# CITY OF ALBUQUERQUE

**RE:** UNM Starbucks and Freddie's  
Grading and Drainage Plan  
Engineer's Stamp Date 2-22-2017 (File: K16D075)

**RE:** UNM Starbucks and Freddies  
Grading and Drainage Plan  
Engineer's Stamp Date 1-27-2017 (File: K16D075)

ENGINEER'S SEAL	STARBUCKS/FREDDY'S	DRAWN BY WCHU
	GRADING AND DRAINAGE PLAN	DATE 12-27-17
		STUDY AREA - 1-10-17
	<i>Rio Grande Engineering</i> 1808 CENTRAL AVENUE SE SUITE 201 ALBUQUERQUE, NM 87106 (505) 875-0888	SHEET # —
DAVID SOULE P.E. #14522		JOB # 21702

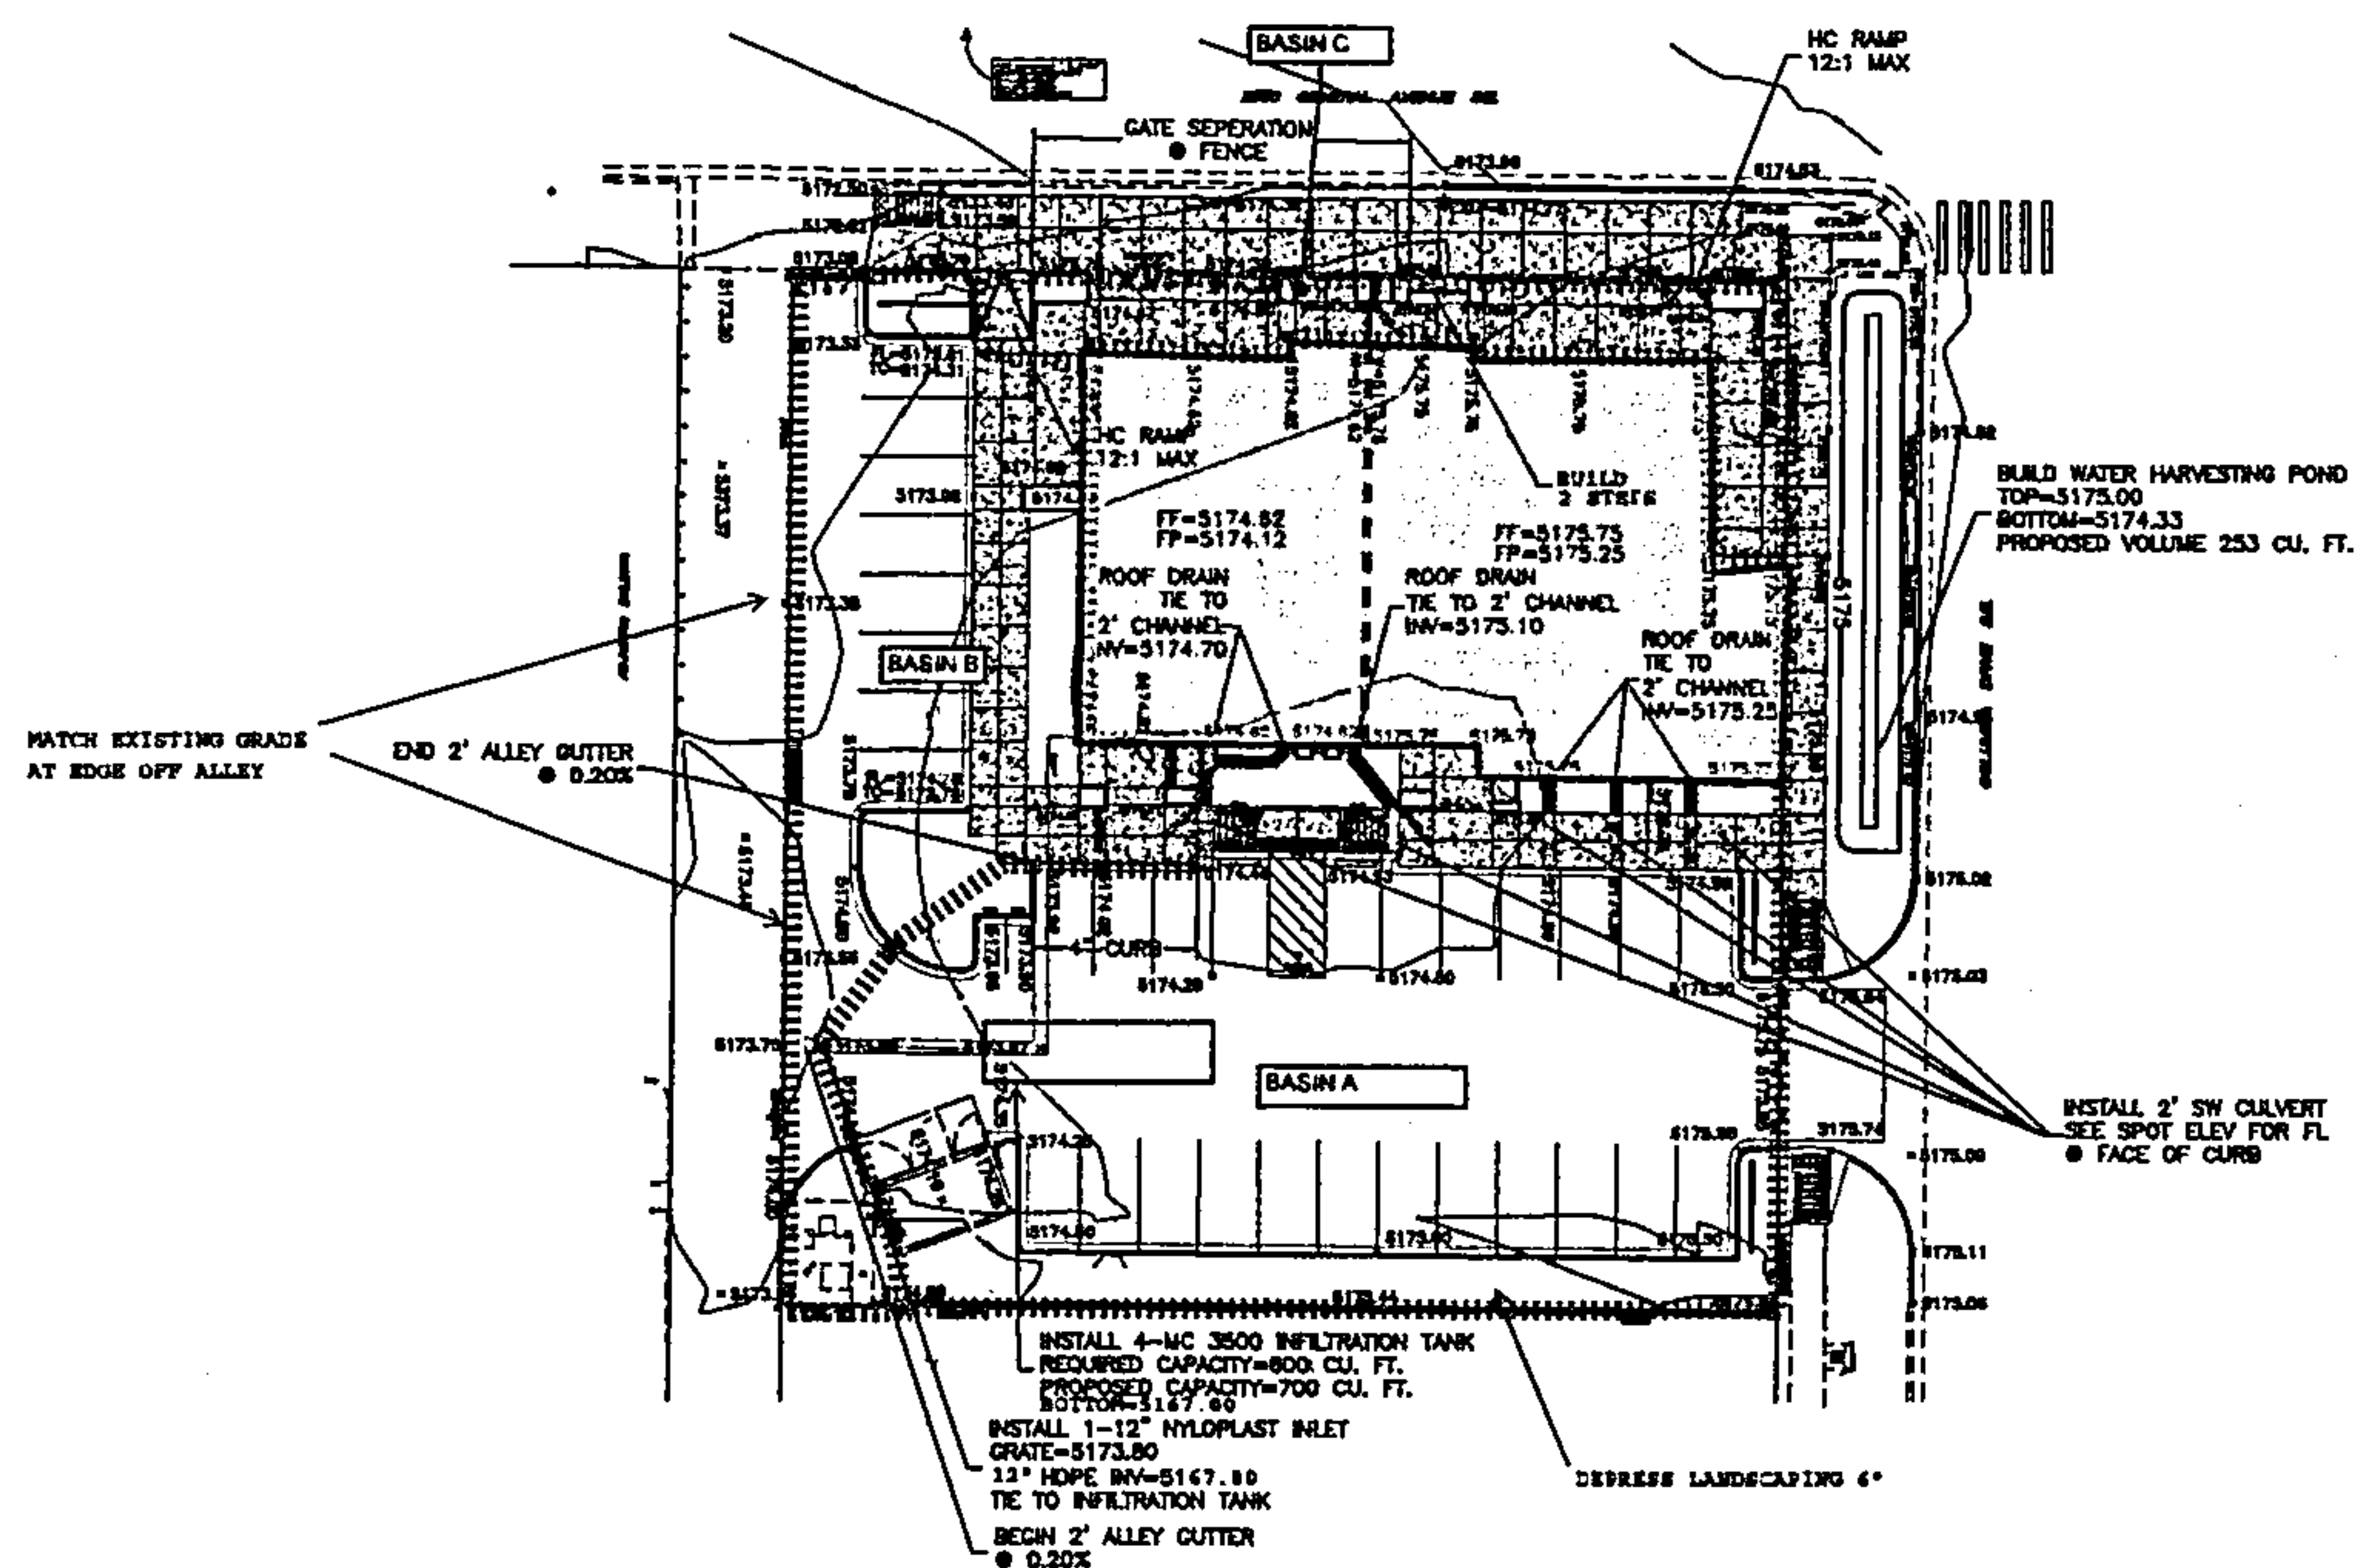
1. Provide build note and grade elevation for the dumpster.
2. Provide narrative for offsite flow.

THIS SITE IS A REDEVELOPMENT OF AN EXISTING SITE . THE EXISTING SITE DISCAHRGES 2.22 CFS TO A PUBLIC ALLEY. THE PROPOSED DEVELOPMENT GENERATES LESS THAN EXISTING FLOW RATES. THE FIRST FLUSH VOLUME WILL BE RETAINED BY THE PLACEMENT OF A INFILTRATOR SYSTEM AT THE OUTFALL FLOW LINE. THE SITE MATCHES THE EXISTI DRAINAGE PATTERNS. AND WILL TIE TO THE EXISTING ALLE NO UPLAND FLOWS IMPACT THE PROPERTY, DUE TO WATER CURB AND GUTTER AND WATER BLOCKS AT DRIVEWAYS
